P–7382–3
S2064
25779

JINDAL SYMBOL OF QUALITY AN ISO 9001 COMPANY	*JINDAL ALUMINIUM LTD.* *BANGALORE–560073 (INDIA)*		NAME	DATE
		DRAWN	PRASANN. H	03–12–2007
		CHECKED		
		APPROVED		
1. ALL DIMENSIONS ARE IN mm. 2. ROUND OFF ALL SHARP CORNERS WITH 0.40 mm. 3. TOLERANCES WILL BE AS PERIS:6477–1983 UNLESS OTHERWISE SPECIFIED		SCALE		1:1
		AREA mm^2		859.732
		PERIMETER mm.		519.781
		WEIGHT kg/m		2.321
PARTY'S NAME	LINKWELL TELESYSTEMS PVT. LTD., HYDERABAD	DRAWING No.		SECTION No.
PARTY'S DRAWING No.	31261602–0021/REV–B	P–7382–3		–
ALLOY & TEMPER	6063 T6	S2064		S2064–ISSUE–5
DESCRIPTION	MISC. PROFILE	25779		25779

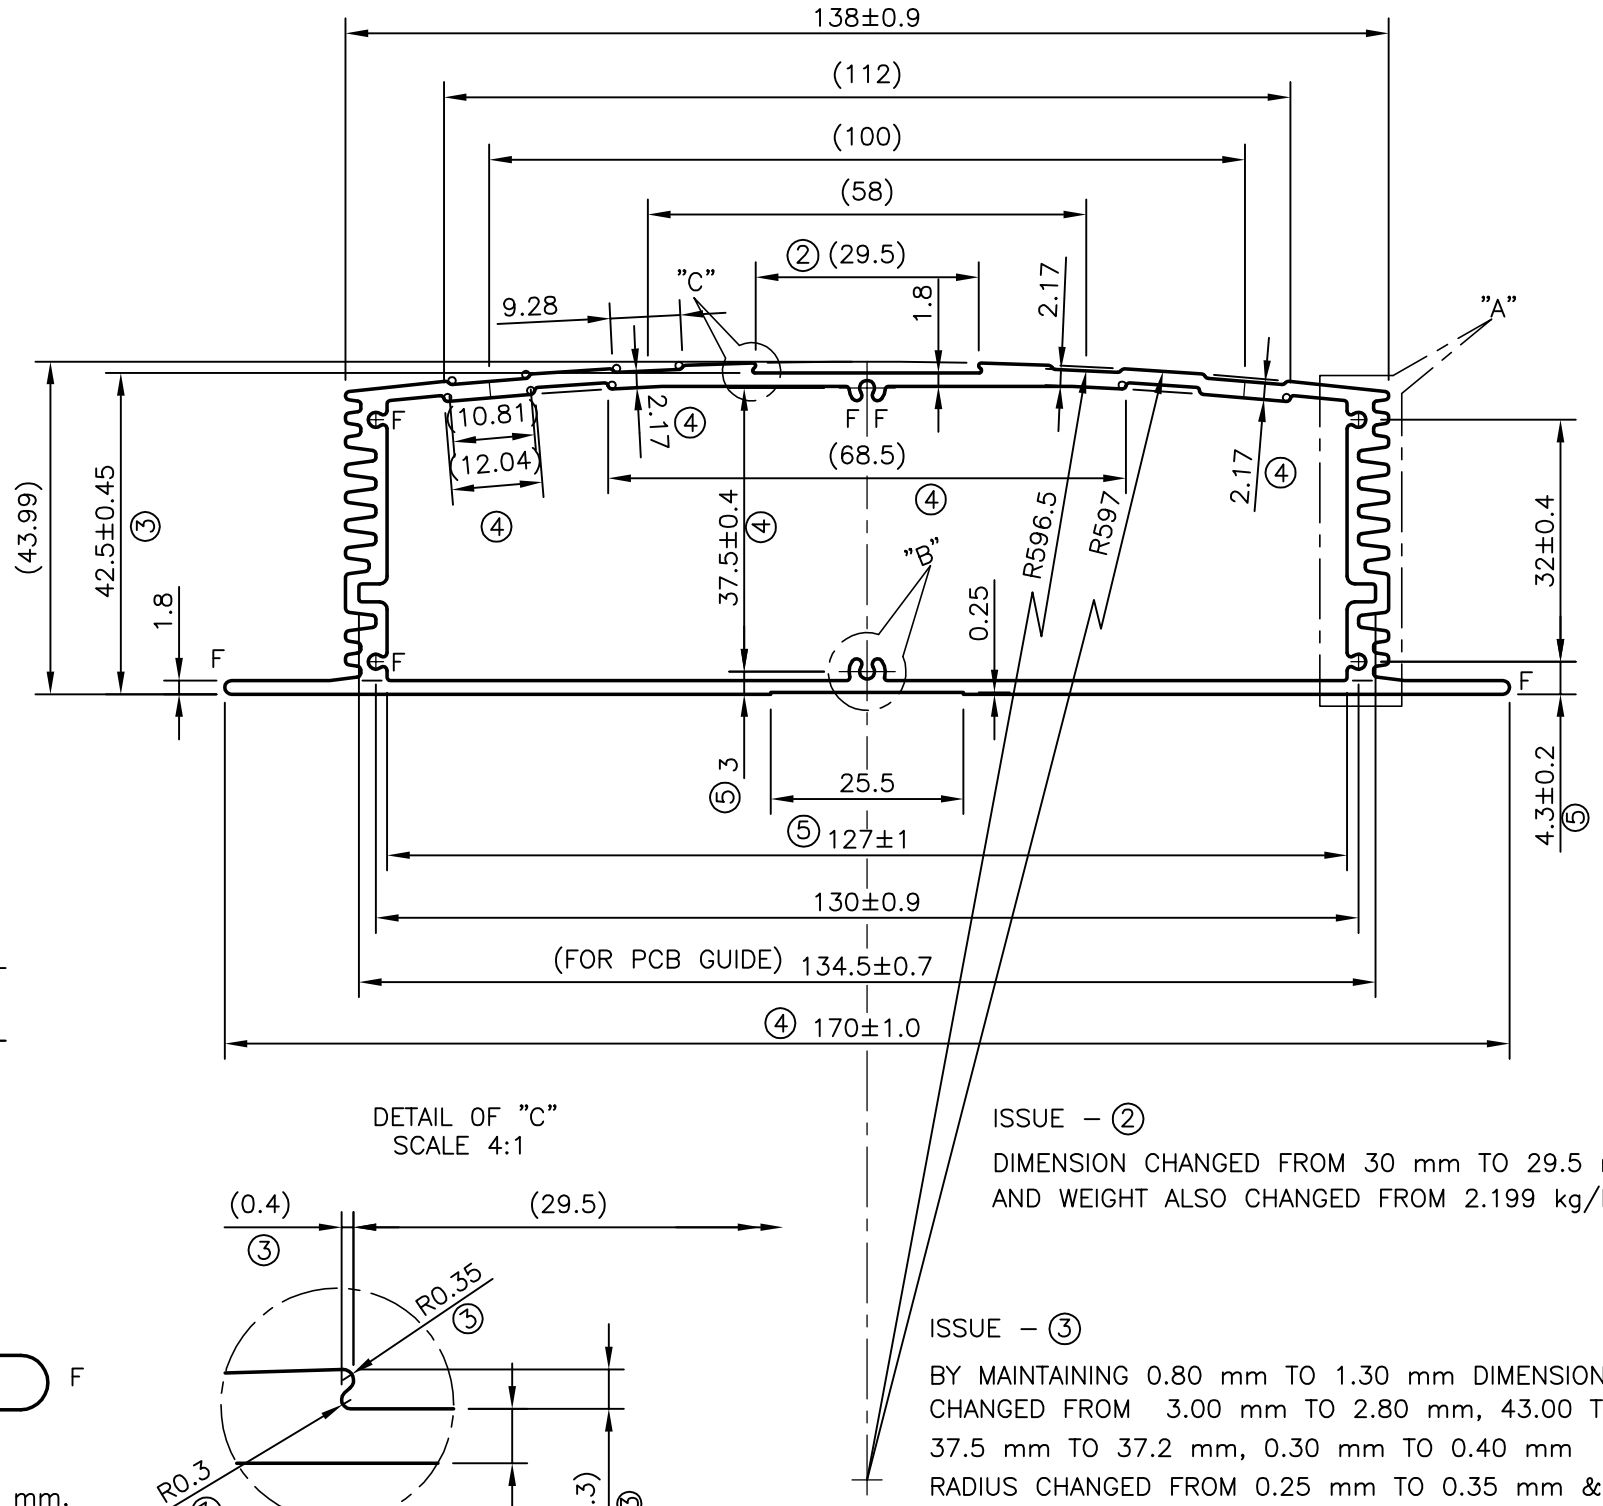
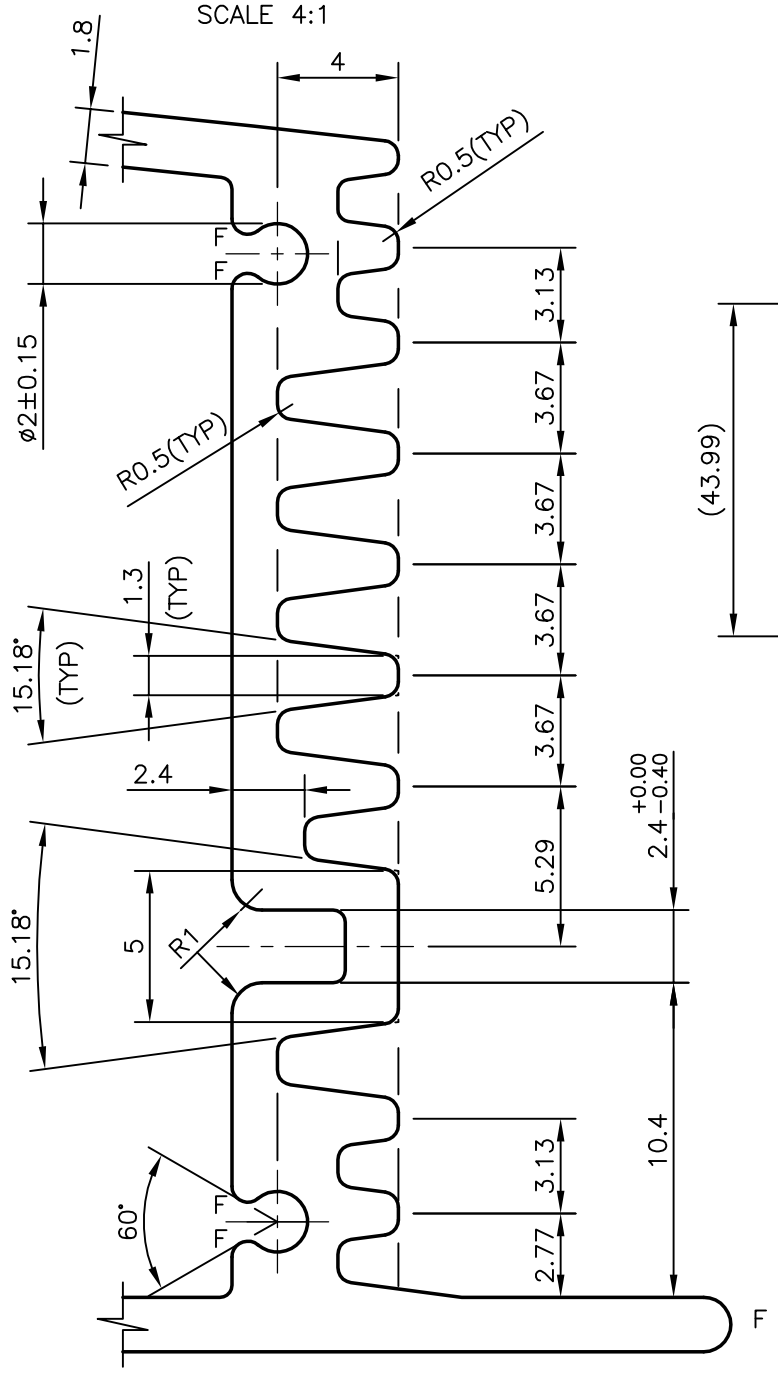
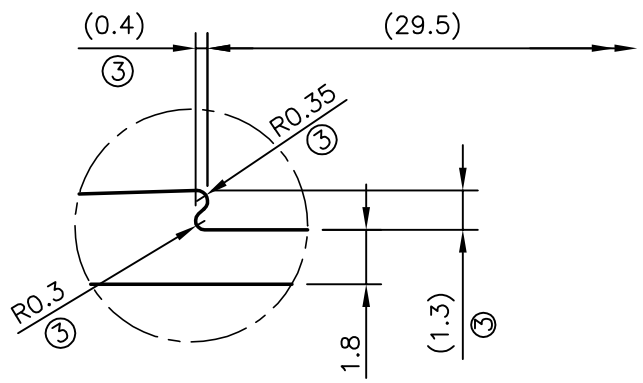
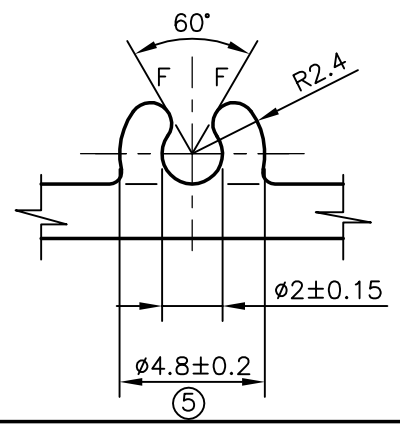
DIMENSION CHANGED FROM 30 mm TO 29.5 mm
AND WEIGHT ALSO CHANGED FROM 2.199 kg/M TO 2.201 kg/m

BY MAINTAINING 0.80 mm TO 1.30 mm DIMENSION, DIMENSIONS CHANGED FROM 3.00 mm TO 2.80 mm, 43.00 TO 42.5 mm, 37.5 mm TO 37.2 mm, 0.30 mm TO 0.40 mm
RADIUS CHANGED FROM 0.25 mm TO 0.35 mm & 0.15 mm TO 0.3 mm
WEIGHT ALSO CHANGED FROM 2.201 kg/m TO 2.200 kg/m

DIMENSIONS CHANGED FROM 32.00 mm TO 68.5, 37.20 mm TO 37.50 mm, 1.80 mm TO 2.17 mm & 12.3 mm TO 12.04 mm, 160 mm TO 170 mm, DIMENSIONS ADDED 25.5 mm & 0.25 mm,
WEIGHT ALSO CHANGED FROM 2.200 kg/m TO 2.322 kg/m

TOLERANCES ADDED FOR 127±1, ø4.8±0.2, 10.4±0.3
